# Access Compliance Report

## Public Rights-of-Way

| Intersection ID: 7523                   | Main Street: COTTONWOOD_ST | Cross Street: N_GRAHAM_ST               | Location: SE           |
| ADA ID: AAA5685FAB5B                    | Ramp Type: Perp            | Initial Pass/Fail: Fail                 | Overall Compliance: No |

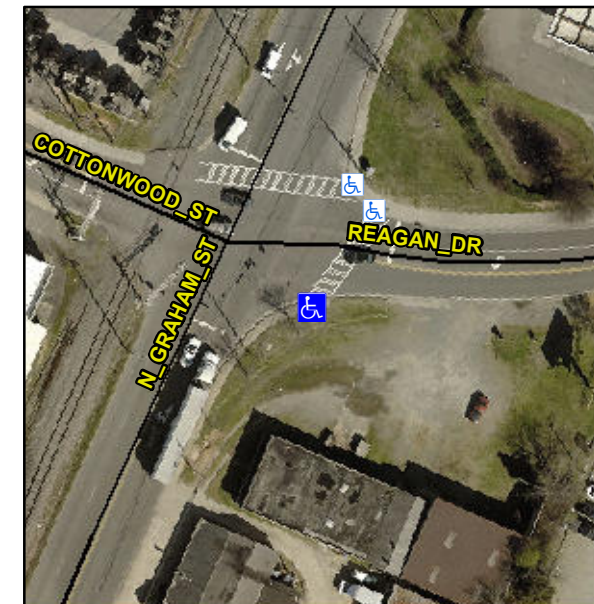
**Not Found, R304.5.1**

| Compliance | Description           | Data  | Compliance | Description                 | Data |
|------------|-----------------------|-------|------------|-----------------------------|------|
| No         | Ramp Width (in)       | 45.5  | Yes        | Ramp XSlope (%)             | 1.7  |

**Remove & Replace Entire Ramp.**
